## Technical Note TN-724

# Power Problems with “-2XX” 66-88MHz T2000s

4<sup>th</sup> November 2002

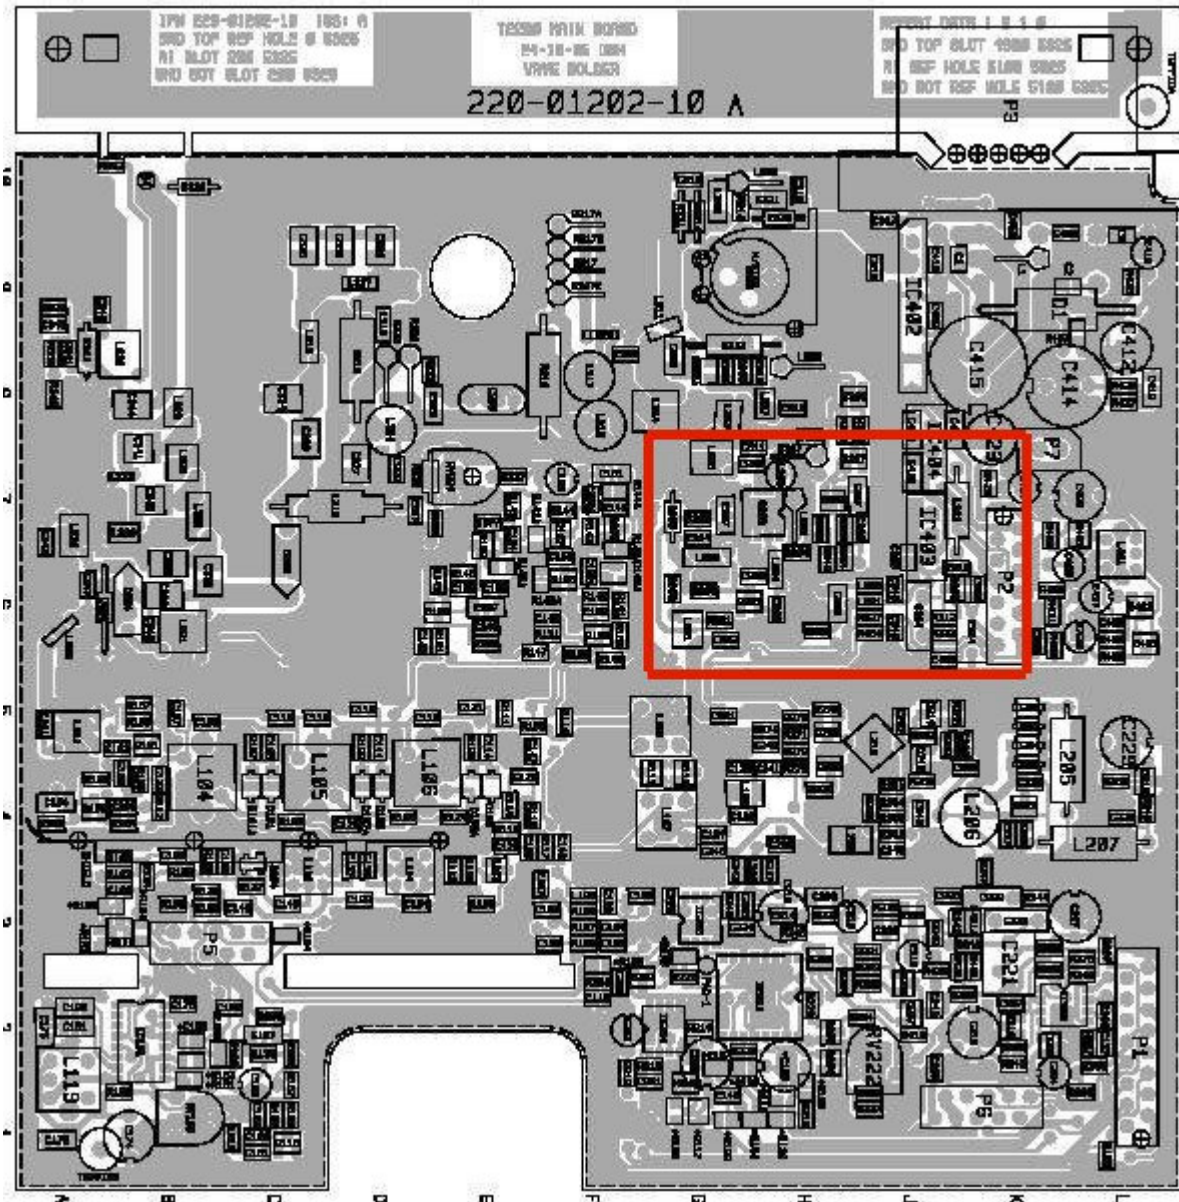
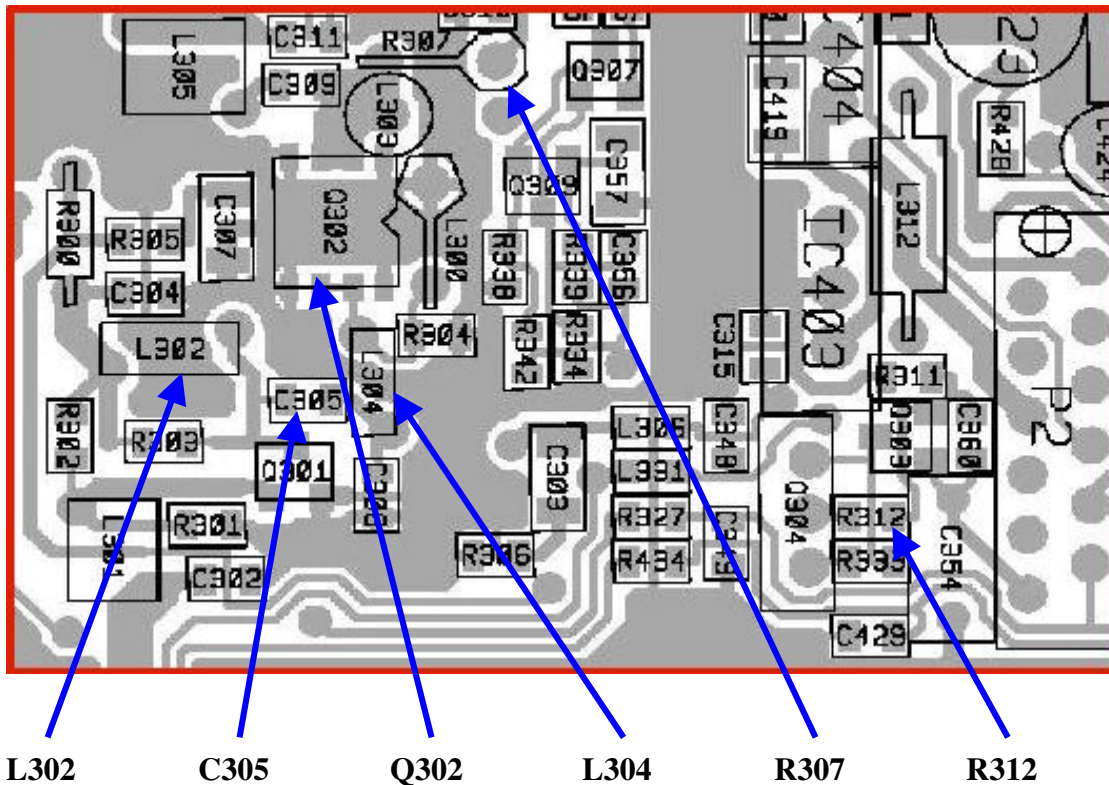
It has been found that the T2000 66MHz to 88MHz RF boards that use the Microsemi MRF3866 transistor may have a power sag problem causing the radios, after a period of operation, to reduce power output eventually to zero watts. This only happens on radios operating above 80MHz.

While unintentional by the component manufacturers, Tait have been required to make changes to the circuitry. It will also mean that any replacement of the Microsemi MRF3866 (Q302) in the field will require the replacement of the components listed below.

- **Changing Q302 from 000-10386-60 (MRF3866) to 000-10144-27 (MSMRF4427)**
- **Changing R307 from 030-53330-20 (330E) to 030-53120-20 (120E)**
- **Changing R312 from 036-13680-00 (680E) to 036-13390-00 (390E)**
- **Changing C305 from 015-23120-01 (120P) to 015-23180-01 (180P)**
- **Changing L304 from 052-56135-25 (2.5T/3.5MM) to 052-08132-15 (1.5T/3.2MM)**
- **Changing L302 from 052-56145-35 (3.5T/4.5MM) to 052-08145-25 (2.5T/4.5MM)**
